OBJECT: NEW HP POPPET SEAT FOR MR FIRST STAGES (CODE: 46186216)

THE TECHNICAL ASSISTANCE DEPARTMENT OF MARES S.P.A. ANNOUNCES A MODIFICATION TO THE PROFILE AND MATERIAL OF THE HP POPPET SEAT USED IN ALL OF MARES MR FIRST STAGES.

PICT.1

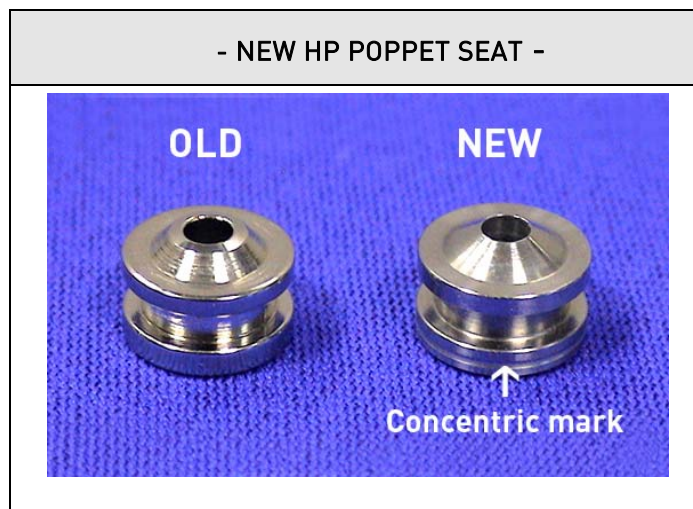
THE NEW HP POPPET SEAT WAS DESIGNED AND TESTED TO GUARANTEE A GREATER RESISTANCE TO WEAR AND TEAR. THE NEW HP POPPET SEAT SHOULD ONLY BE USED WITH THE TRI-MATERIAL POPPET, (CODE: 46200652)

THE NEW HP POPPET SEAT CAN BE EASILY IDENTIFIED BY THE RADIAL THROAT DESIGN UNDER THE SEAT OF THE OR-RING (AS SHOWN IN PICTURE 1 BELOW).

DO NOT ATTEMPT TO USE THE NEW HP POPPET SEAT WITH MARES OLDER STYLE RUBBER POPPET (CODE: 46185002). THE PROFILE OF THE NEW HP POPPET SEAT CAN DAMAGE THE RUBBER POPPET SURFACE CAUSING A FREE-FLOW.
